**CORRESPONDENCE COVER SHEET
WASTE PERMITS DIVISION
TEXAS COMMISSION ON ENVIRONMENTAL QUALITY**

Date: May 17, 2019
 Facility Name: City of Kingsville Landfill
 Permit or Registration No.: MSW 235-C

Re: City of Kingsville Landfill – Kleberg County
Municipal Solid Waste (MSW) - Permit No. 235C
Permit Amendment Application – Supplemental Information
Tracking No. 23301130, 23458984, and 24040819; RN102334570/CN600674246

On behalf of the City of Kingsville and in response to your May 10, 2019 and May 16, 2019 email requesting supplemental information, we hereby submit the enclosed response regarding the Permit Amendment Application for the above referenced MSW facility.

**FIGURE:
1.-2-5**

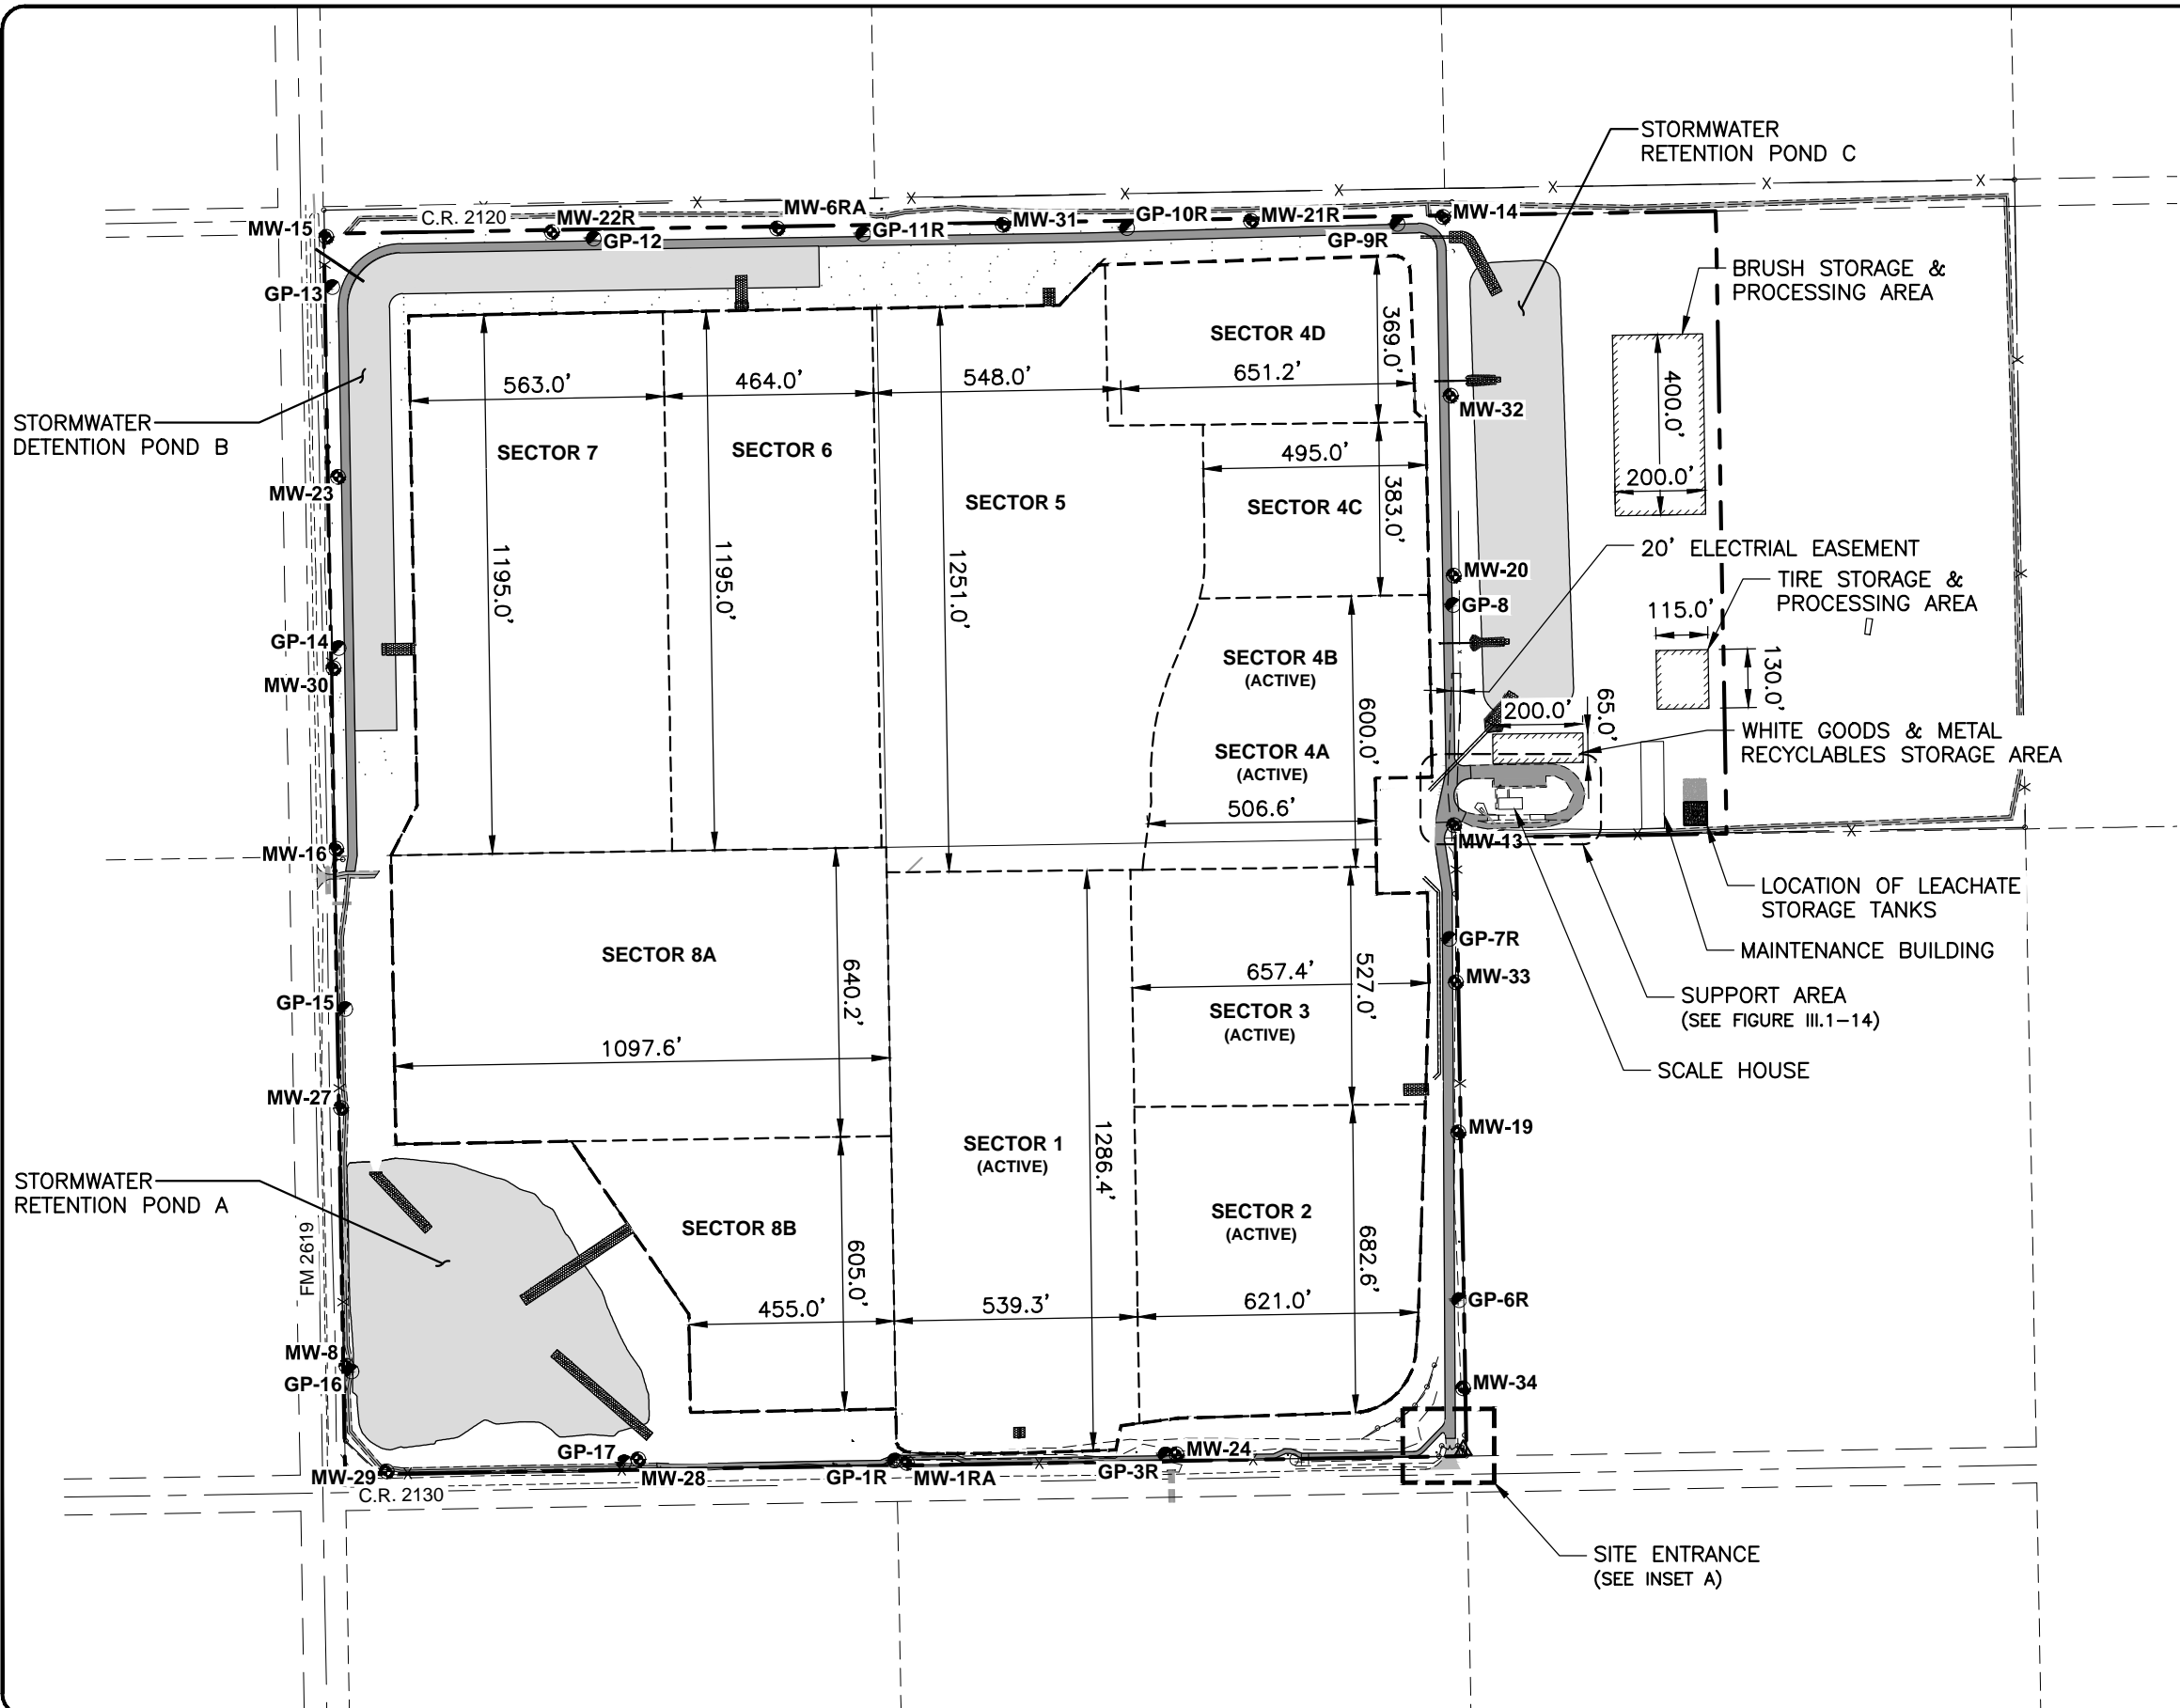
ID	Checklist Item	Citation
833	Indicate that no unloading, storage, disposal, or processing operations will occur within easements, buffer zones, or rights-of-way that crosses the site, and that no disposal shall occur within 25 feet of the center line of any utility line or pipeline easement, unless otherwise authorized by the executive director	330.141(a)
Location		NOD Type
Vol 6, Sec 4.10, pg 35		Incomplete
NOD Description		
Show the location of the electric easement on Part I, Att 2, Fig I.2-5 (or remove the reference from the text).

The location of the electric easement was added to Part I, Attachment 2, Figure I.2-5 as part of the response to the 1st Technical Notice of Deficiency submitted on February 15, 2019. A copy of the Attachment 2, Figure I.2-5 submitted on February 15, 2019 is attached.
